H. B. Barron  
Vice President

Re: Duke Energy Corporation

Catawba Nuclear Station Unit 1, 2  
USNRC License NPF No. 35 and NPF No. 52  
USNRC Docket No. 50-413 and 50-414

Amendment to Technical Specification 3.6.12 - Ice Bed  
Revise Chemical Sampling & Analysis, and  
Flow Area Verification Surveillance Requirements

SR 3.6.12.2

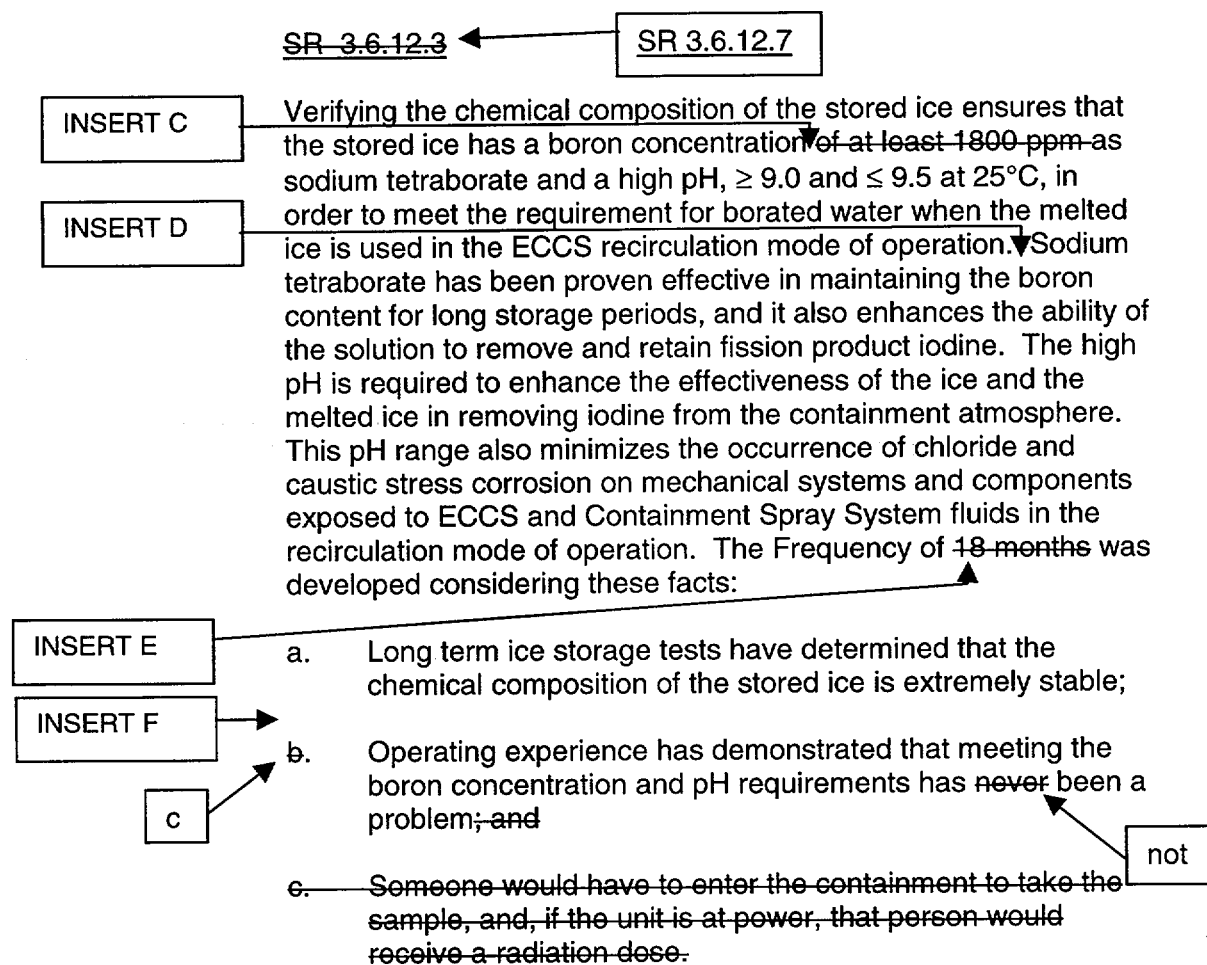
~~This SR ensures that the flow channels through the ice condenser have not accumulated an excessive amount of ice or frost blockage. The visual inspection must be made for two or more flow channels per ice condenser bay and must include the following specific locations along the flow channel:~~

- ~~a. Past the lower inlet plenum support structures and turning vanes;~~
- ~~b. Between ice baskets;~~
- ~~c. Past lattice frames;~~
- ~~d. Through the intermediate floor grating; and~~
- ~~e. Through the top deck floor grating.~~

~~The allowable 0.38 inch thick buildup of frost or ice is based on the analysis of containment response to a DBA with partial blockage of the ice condenser flow passages. If a flow channel in a given bay is found to have an accumulation of frost or ice > 0.38 inch thick, a representative sample of 20 additional flow channels from the same bay must be visually inspected.~~

This SR ensures that the air/steam flow channels through the ice bed have not accumulated ice blockage that exceeds 15 percent of the total flow area through the ice bed region. The allowable 15 percent buildup of ice is based on the analysis of the sub-compartment response to a design basis LOCA with partial blockage of the ice condenser flow channels. The analysis did not perform detailed flow area modeling, but rather lumped the ice condenser bays into six sections ranging from 2.75 bays to 6.5 bays. Individual bays are acceptable with greater than 15 percent blockage, as long as 15 percent blockage is not exceeded for any analysis section.

To provide a 95 percent confidence that flow blockage does not exceed the allowed 15 percent, the visual inspection must be made for at least 54 (33 percent) of the 162 flow channels per ice condenser bay. The visual inspection of the ice bed flow channels is to inspect the flow area, by looking down from the top of the ice bed, and where view is achievable up from the bottom of the ice bed. Flow channels to be inspected are determined by random sample. As the most restrictive ice bed flow passage is found at a lattice frame elevation, the 15 percent blockage criteria only applies to "flow channels" that comprise the area:
